MVEA SADDLEHORN RANCH

GRADING, EROSION, & SEDIMENT CONTROL PLAN

EPC STORMWATER REVIEW COMMENTS ARE SHOWN IN ORANGE BOXES WITH BLACK TEXT

MVEA SADDLEHORN RANCH
GRADING, EROSION, & SEDIMENT CONTROL PLAN
EROSION CONTROL PLAN

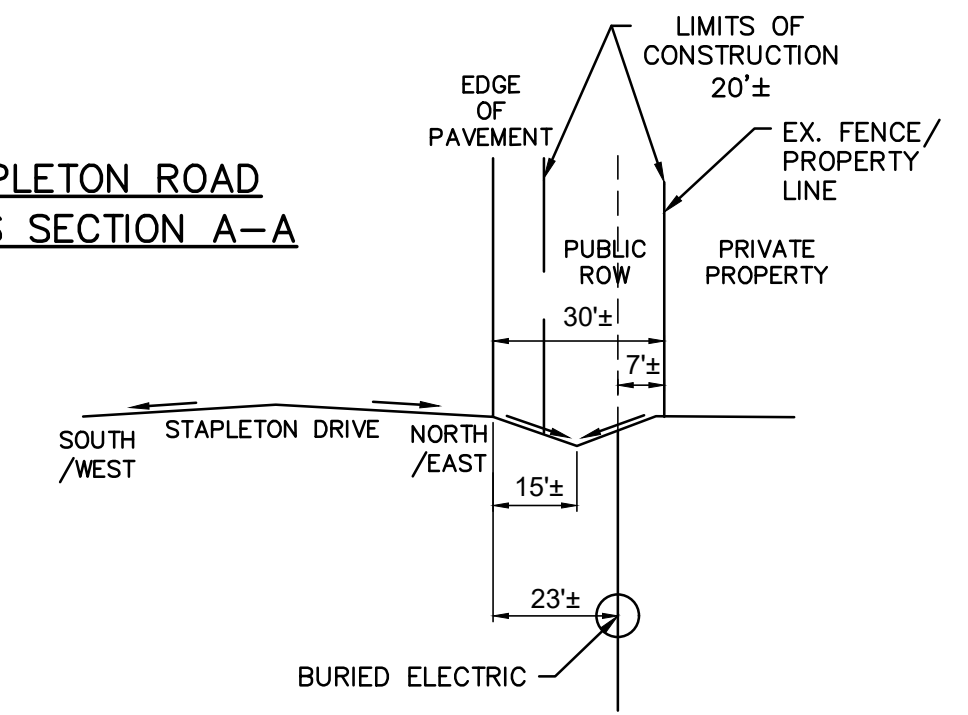
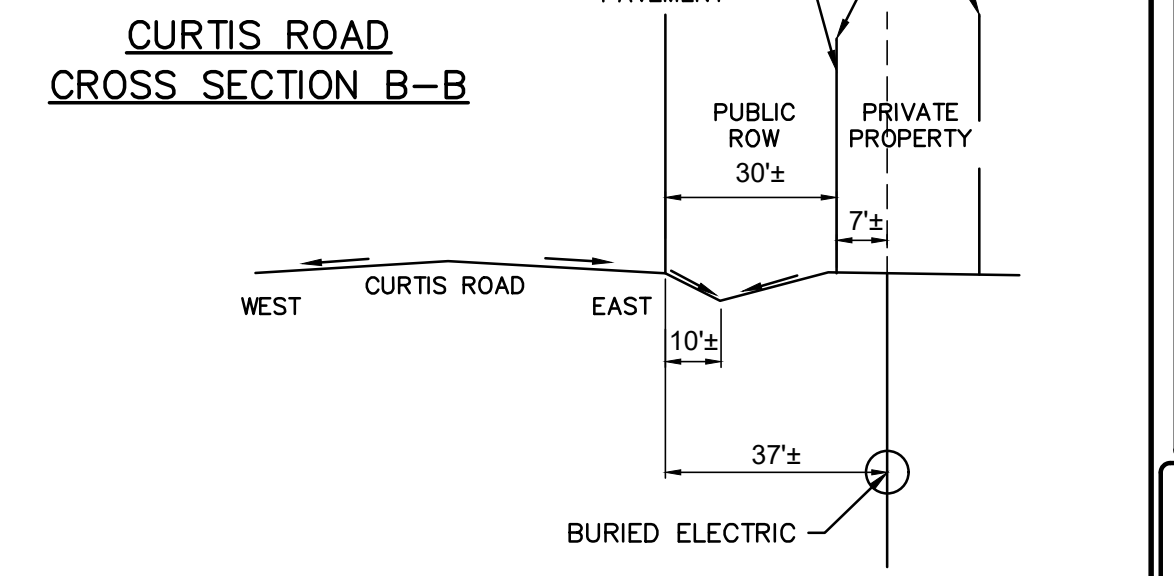
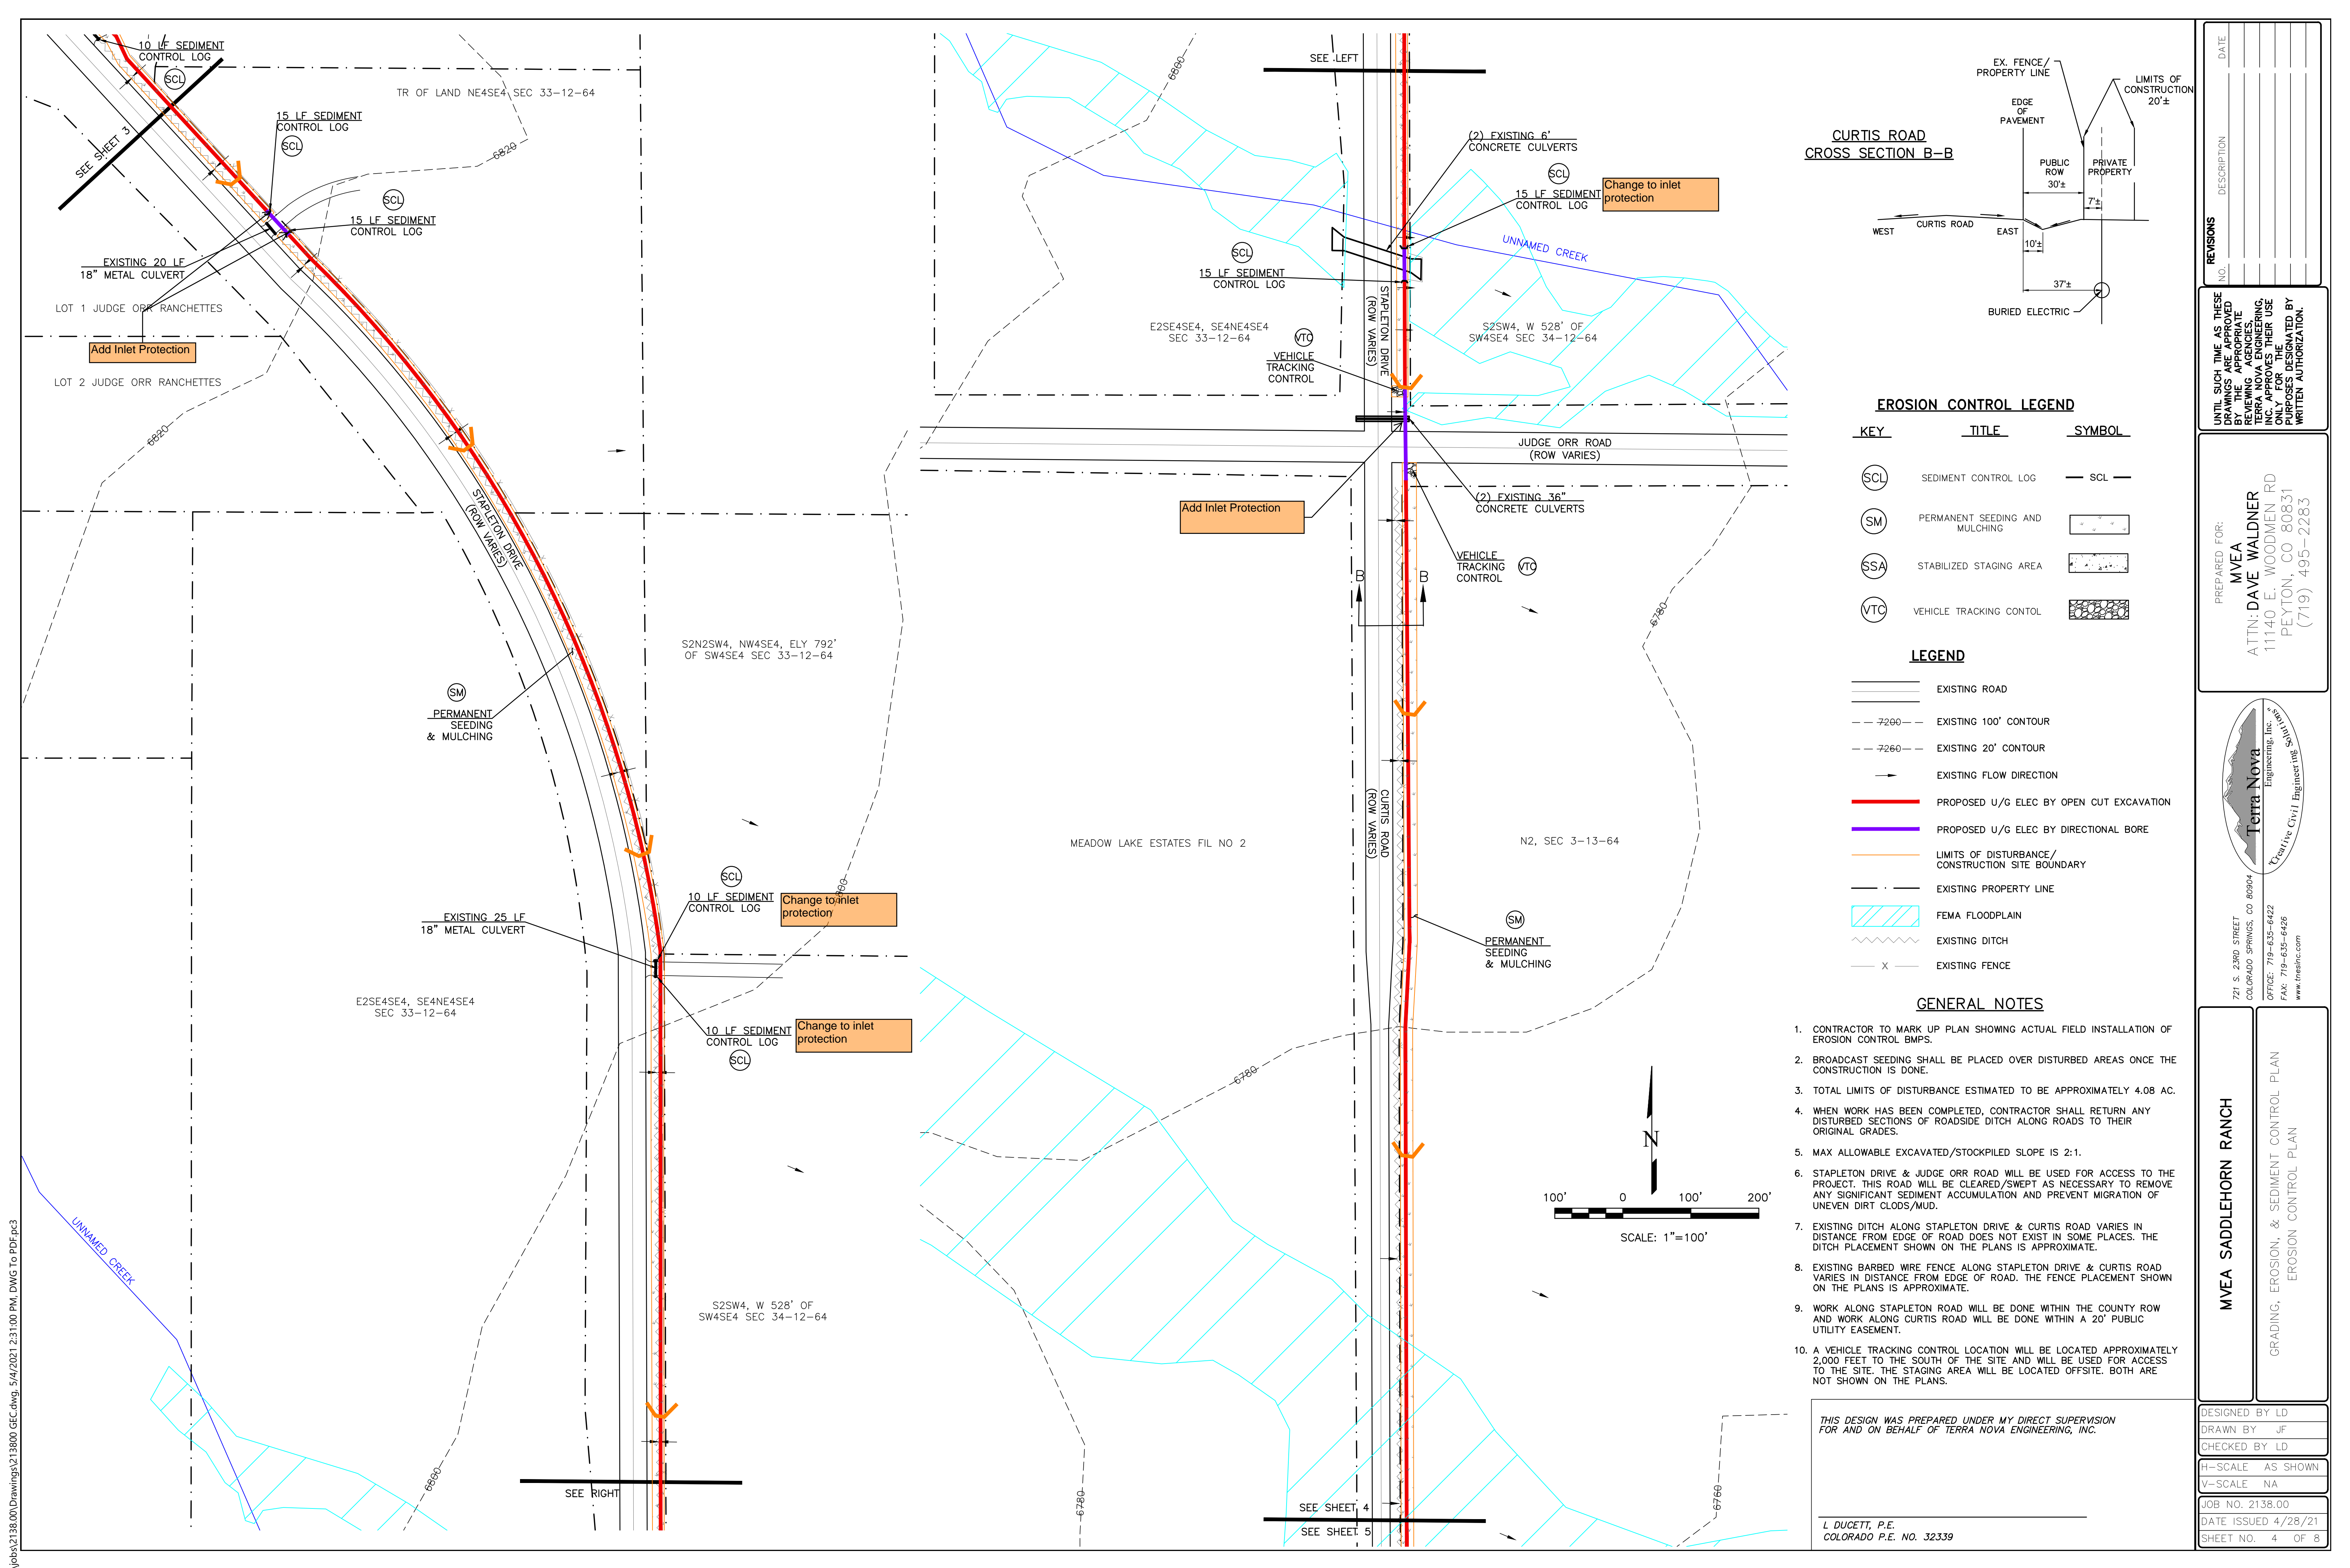
show erosion control (i.e. SCL) along linear excavation.
Suggest 3 SCL stacked like a pyramid to prevent sediment erosion prior to establishing vegetation.

Label all property parcel numbers

show proposed staging and stockpile areas.
show easements

MVEA SADDLEHORN RANCH
 GRADING, EROSION, & SEDIMENT CONTROL PLAN
 EROSION CONTROL DETAILS

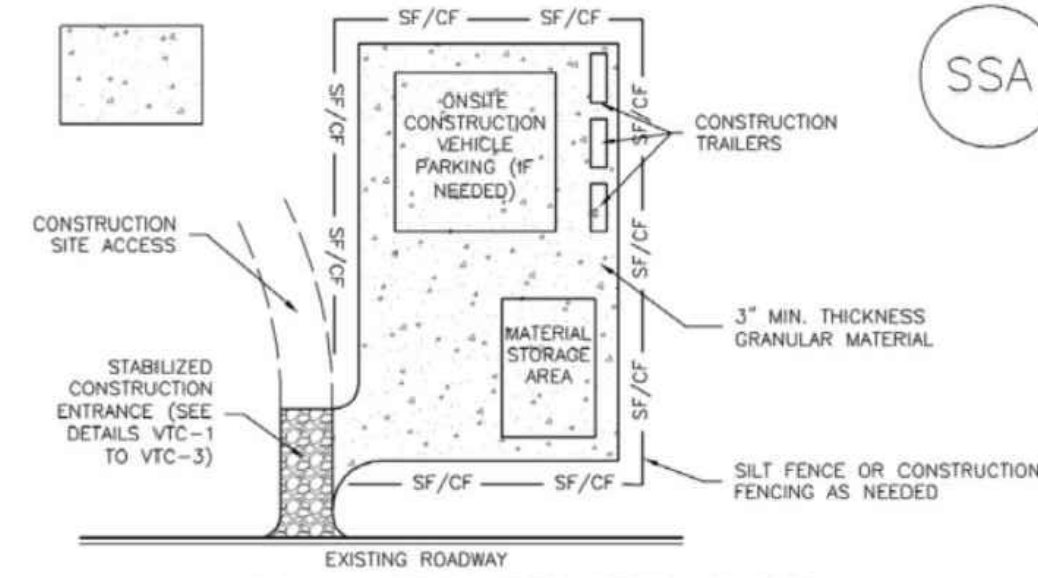
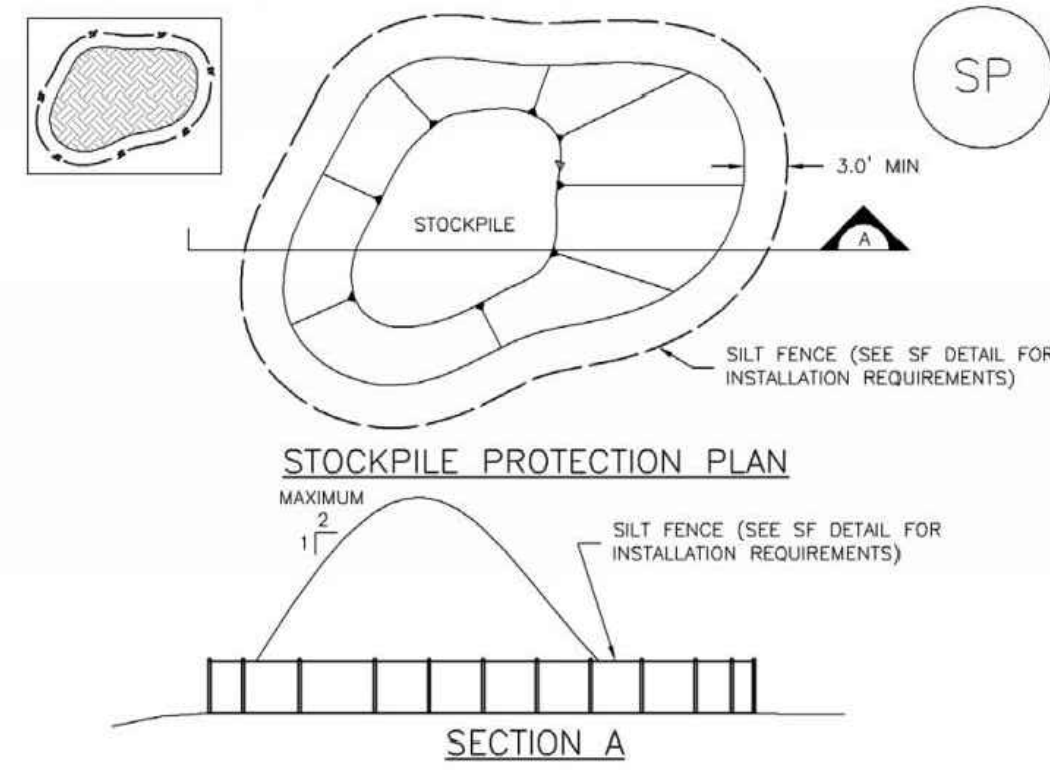
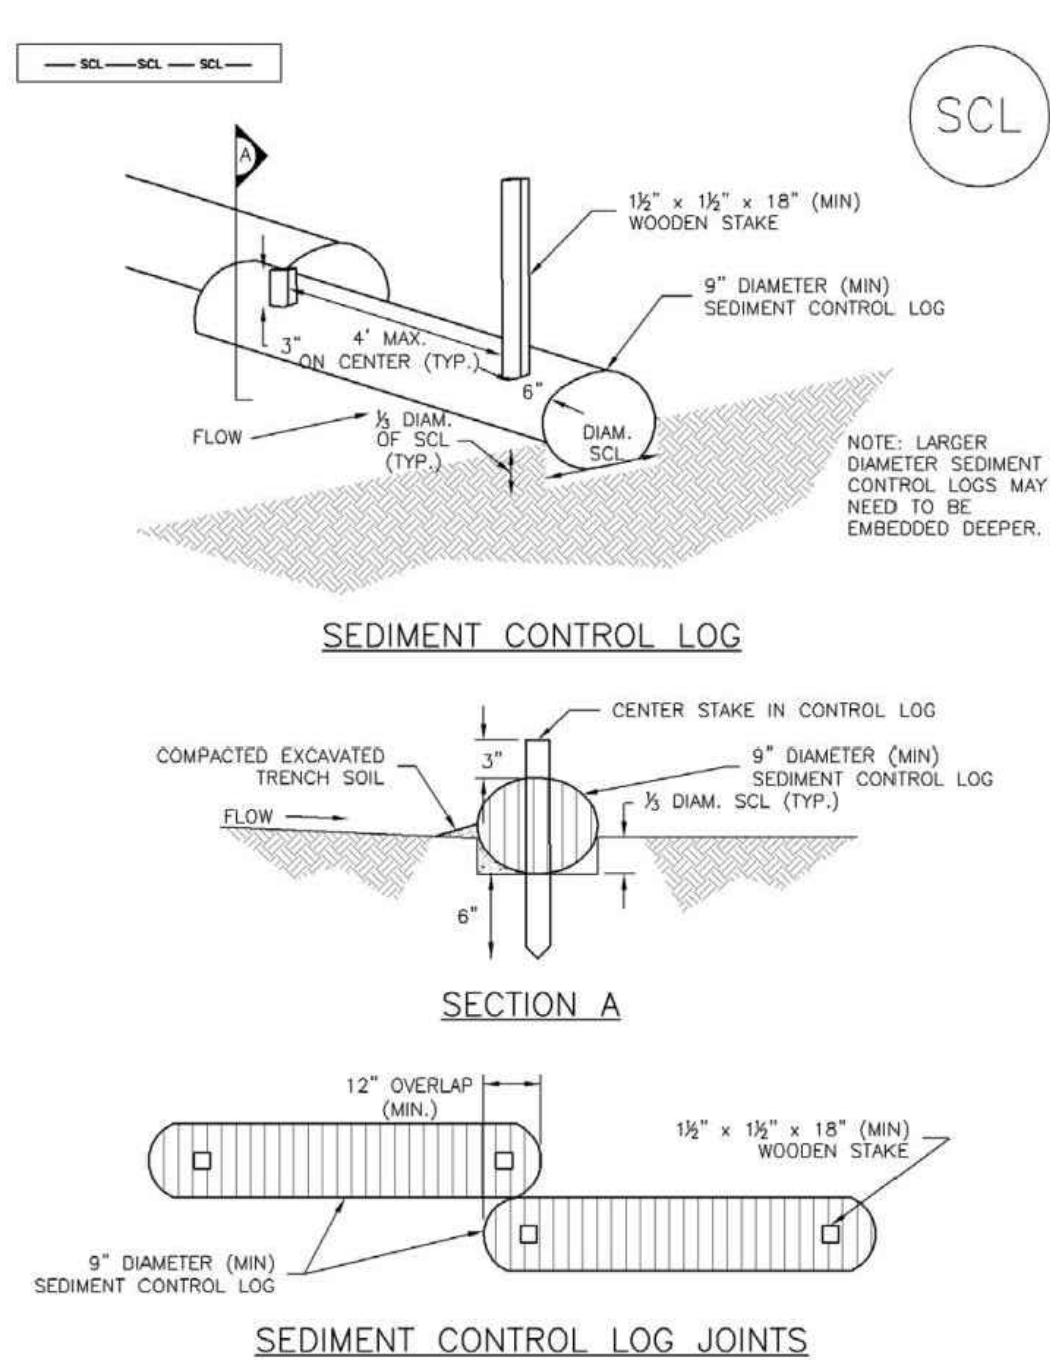
include detail for culvert inlet protection
